Charlotte Historic District Commission Application for a Certificate of Appropriateness

ADDRESS OF PROPERTY 808 East Kingston Avenue, Dilworth Local Historic District HDC 2011-106

SUMMARY OF REQUEST Rear Porch Addition

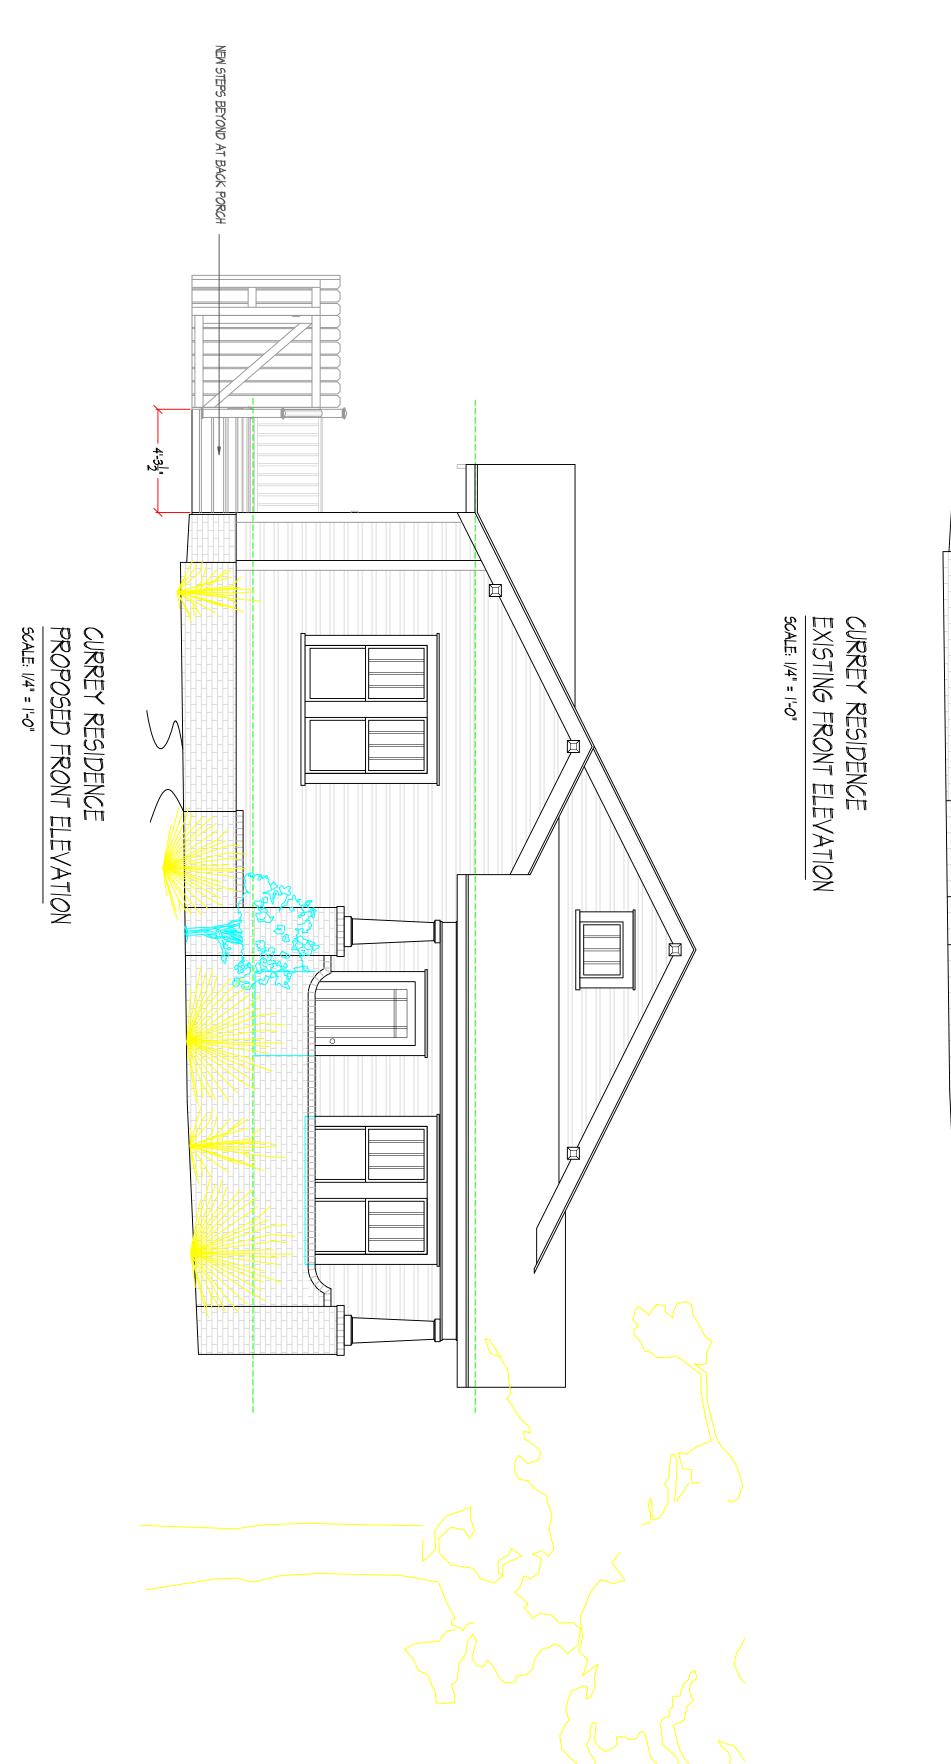
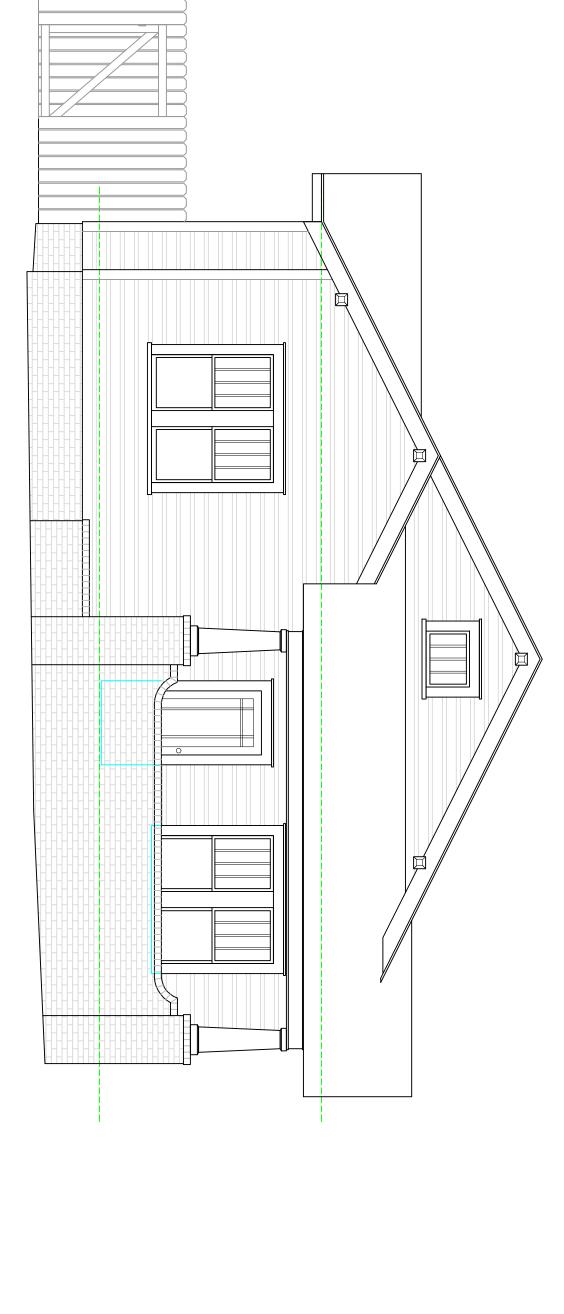
This application requests approval for the construction of rear porch addition. This proposal is ineligible for administrative approval due to a set of steps that are wider than the existing house.

As noted above, this proposal would have been approved administratively if the steps on the left side of the new rear porch addition were not wider than the existing house.

The overall design of the proposed rear porch addition is styled after the front elevation of the house, and is consistent with the house in detailing and materials.
